UNITED STATES ENVIRONMENTAL PROTECTION AGENCY
WASHINGTON, D.C. 20460

**DOCKET NO: A-98-49; II-A4-196
EPA AIR E-DOCKET NO: EPA-HQ-OAR-2001-0012-0448**

**WASTE CHARACTERIZATION TIER 1 CHANGE REPORT
EPA TIER 1 EVALUATION
OF THE CENTRAL CHARACTERIZATION PROGRAM
REMOTE-HANDLED TRANSURANIC WASTE CHARACTERIZATION PROGRAM
FOR THE SAVANNAH RIVER SITE:
ADDITION OF DRUM NUMBER BC0152**

December 2014

Figure 1. Characterization of Drum No. BC0152

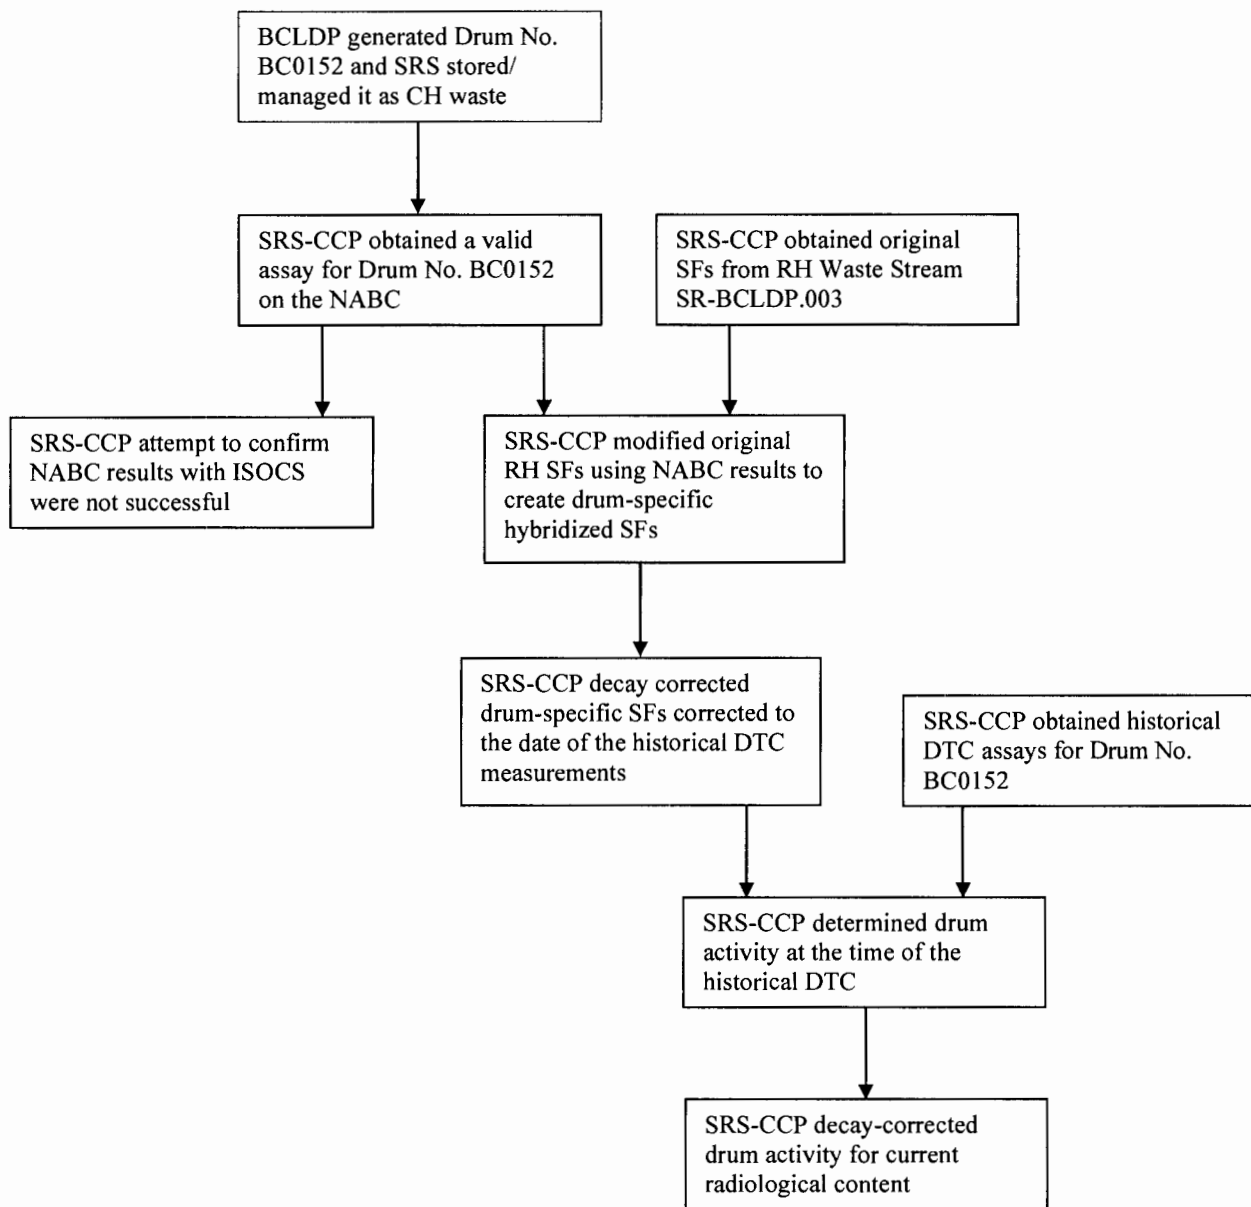
For these reasons, SRS-CCP used the hybridized approach represented in Figure 1 to generate radionuclide-specific scaling factors for Drum No. BC0152. The original SR-BCLDP.003 scaling factors were modified by the NABC assay results, as discussed in Item 2, below. SRS-CCP then applied the historical DTC record from Waste Stream SR-BCLDP.003 to the hybridized container scaling factors to generate the radionuclide content of the drum, as

- (2) EPA found that SRS-CCP correctly derived and appropriately documented cesium-137-based radionuclide scaling factors.

Since SRS-CCP was unable to definitively establish the radionuclide results of Drum No. BC0152 by applying either the initial Waste Stream SR-BCLDP.003 scaling factors or using the NABC results directly, SRS-CCP developed a hybrid set of scaling factors based on the original Waste Stream SR-BCLDP.003 scaling factors that were modified by the NABC results. SRS-CCP determined that the Pu to uranium (U) ratios should remain constant, and adjusted them to account for the ²³⁹Pu to ¹³⁷Cs ratio determined by the NABC using the equation:

SRS-CCP used the ²⁴¹Am ratio provided by the NABC without adjustment and quantified the fission/activation products using the scaling factors from the original Waste Stream SR-BCLDP.003 without modification. SRS-CCP and EPA technical personnel discussed this issue at length. EPA determined that SRS-CCP’s scaling factor development approaches were technically adequate and appropriately documented.
